MONTGOMERY COUNTY HISTORIC PRESERVATION COMMISSION
STAFF REPORT

Address:	514 Philadelphia Avenue, Takoma Park	Meeting Date:	2/10/2021
Resource:	Non-Contributing Resource Takoma Park Historic District	Report Date:	2/3/2021
Applicant:	Michael & Amy Sawyer Brian McCarthy, Architect	Public Notice:	1/27/2021
Review:	HAWP	Staff:	Dan Bruechert
Case No.:	939490	Tax Credit:	n/a
Proposal:	Building addition and front entrance alterations

Figure 1: 514 Philadelphia Ave. is located on a wooded double lot.

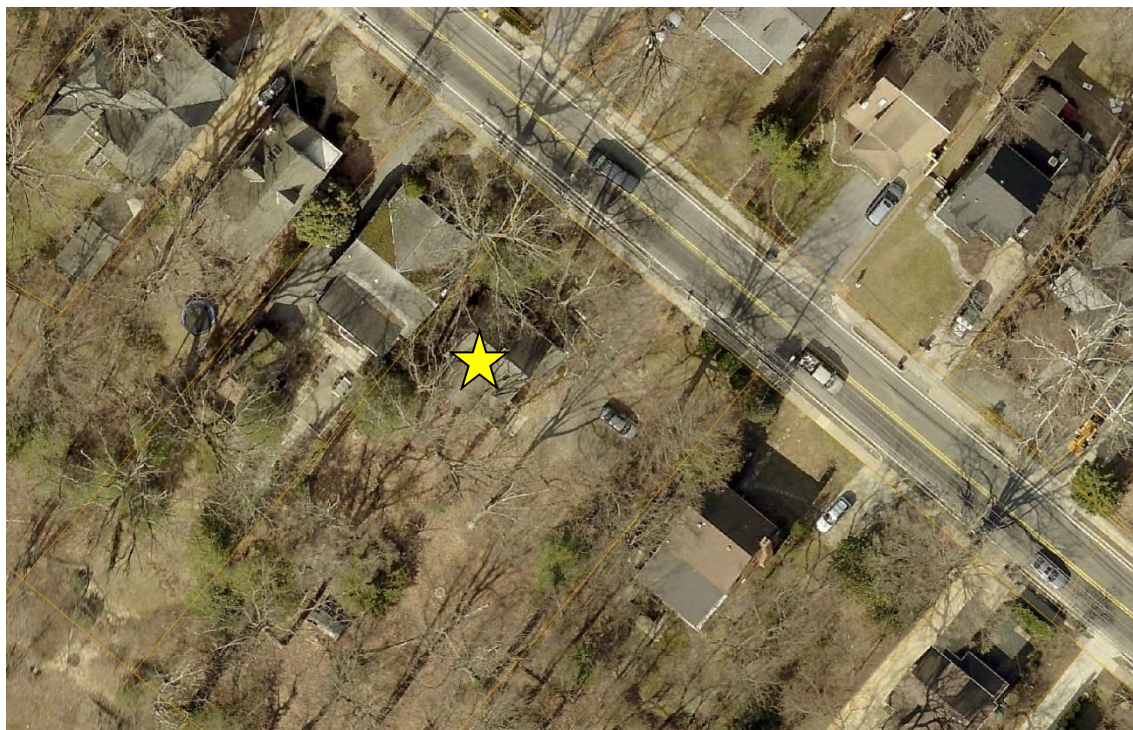
The subject property is a side gable Colonial Revival house clad in wood shingle siding. On the left (east) side of the house, there is a one-story enclosed sunroom; and there is a two story-rear gable addition. The later additions are clad in cedar shingles. The house was constructed on a double lot as far to the west as possible, leaving a large open lot to the left (east) of the building. The rear of the lot is heavily wooded. The neighboring property at 510 Philadelphia is also a double lot, with the house placed on the western side.

Figure 3: HAWP Proposal.

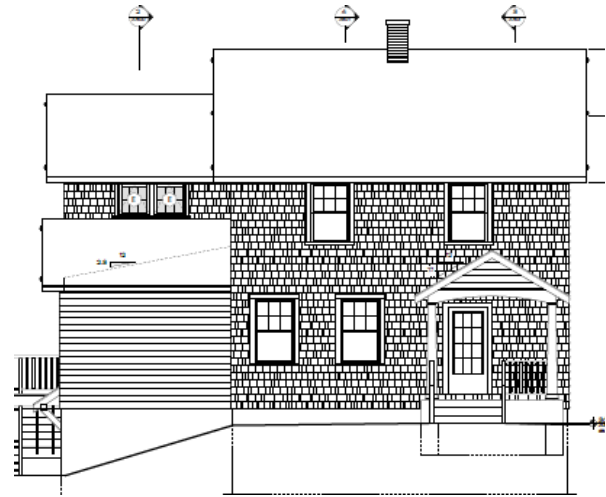
Staff finds that the one-story addition will not substantially impact the character of the resource or surrounding district because it is relatively small in scale, matches the details of the house, and copies the side gable form. The one design element that gives Staff some pause is the elimination of a window in the side-projecting addition. At the preliminary consultation, the design presented included a single sash window in the side-projecting addition (below, left); that feature has been eliminated and the proposal now calls for a blank wall (below, right).

Staff finds that the addition's design would be improved with a window on this elevation, however, Staff does not find support in the *Design Guidelines* for including a condition to require the fenestration on this elevation. Staff also finds there are a couple of mitigating factors that reduce the impact of this blank wall on the surrounding district. First, the side projection is setback from the front wall plane by more than 4' (four feet). The second mitigating factor is the large window assembly on the east elevation (shown below). This window does not show up in the drafted front elevation, however, it will be highly visible when the building is viewed from an oblique angle. Because the house was placed on the western side of the lot, it is most visible from the east.
